# SERVICE BULLETIN

Number: 97-5-1

## **Subject:** RV-4 Rear Sear Bulkhead Reinforcement

**SERVICE BULLETIN 97-5-1**  
**FIG. 1 (ref. RV-4 DWG 28)**  
 Adding the F-482 gussets to the main longeron.

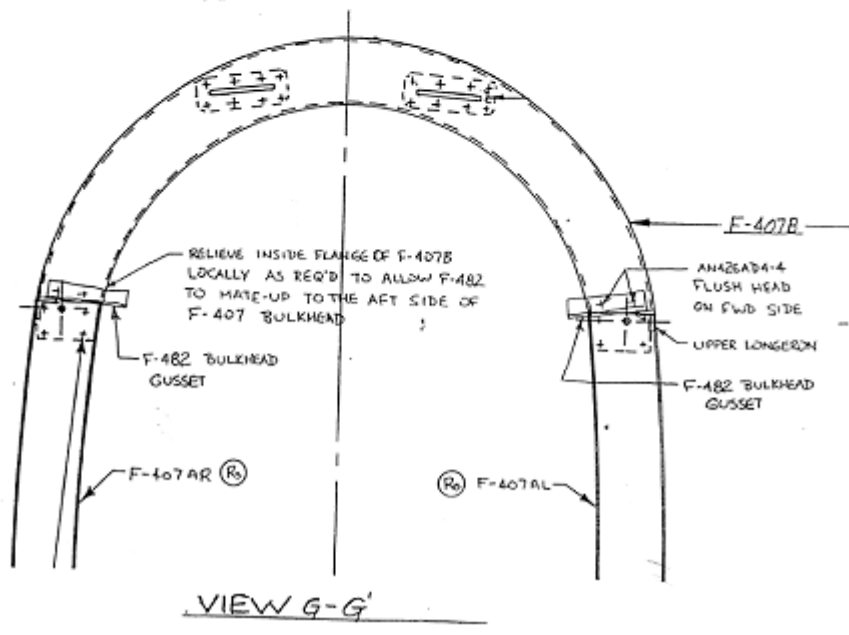
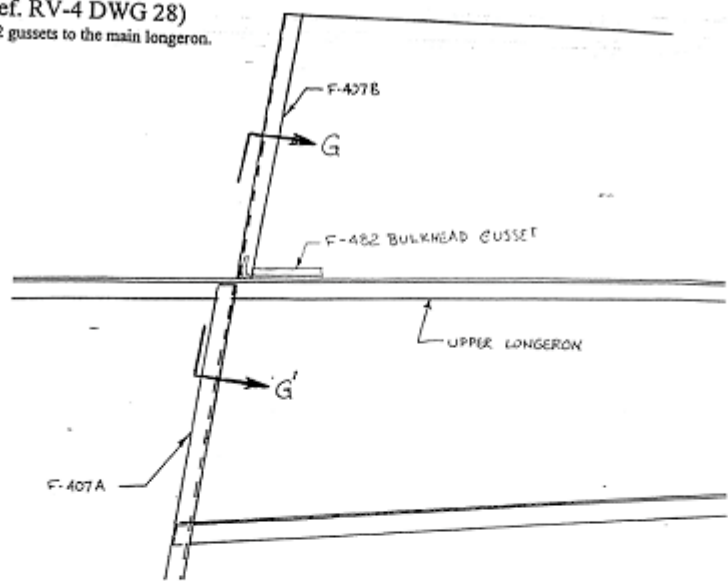
The two F-482 Bulkhead Gussets (one right and one left) are installed on the upper surface of the main longeron immediately aft of the F-407 fuselage bulkhead (see Figure 1). The bulkhead gussets attach to the longeron using four AN470AD4-5 rivets per side, and to the fuselage bulkhead using two AN426AD4-4 rivets per side (see Figures 1 & 2).

The inboard flange of the fuselage bulkhead ring must be trimmed to allow the gusset to properly rest on the aft side of the fuselage bulkhead (see Figure 1).

FIG. 2 (ref. RV-4 DWG 28)

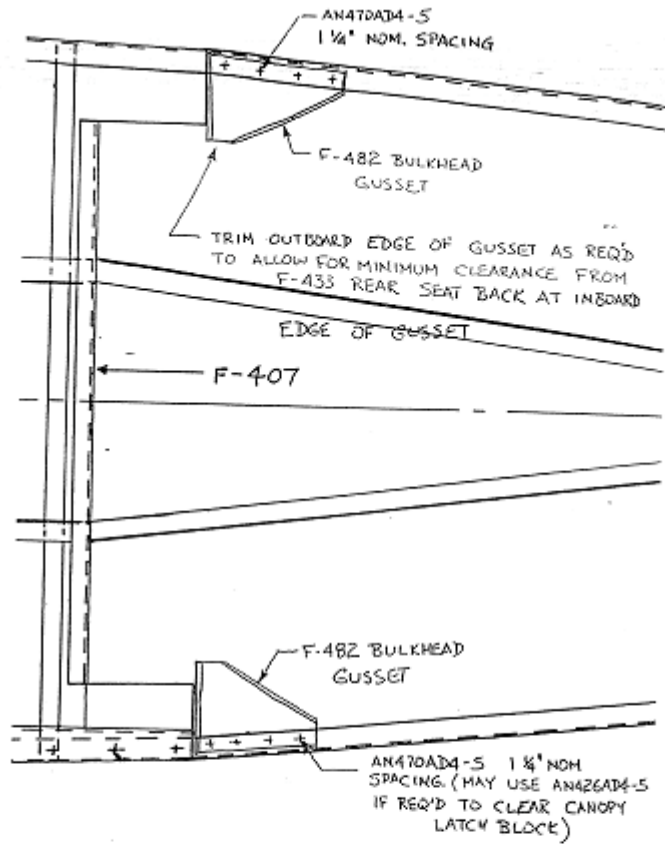
The F-482 Bulkhead Gussets are slightly too wide to clear the F-433 Rear Seatback Assembly if installed "as provided". The outboard edges of the gussets should be trimmed so the inboard edges of the gussets *just* clear the rear seatback assembly, allowing the seatback to rotate forward and give access the baggage compartment (see Figure 2). This minimum clearance will ensure maximum support for the rear seatback assembly.

The F-482 Bulkhead Gusset installation on the left side of the fuselage will require removal of the rear canopy latch block. The bottom surface of the canopy latch block may need to be trimmed prior to re-installation to allow for the additional thickness of the bulkhead gusset. AN426AD4-5 rivets may be used instead of AN470AD4-5 rivets if the additional clearance provided by having flush head fasteners is deemed necessary (see Figure 2).
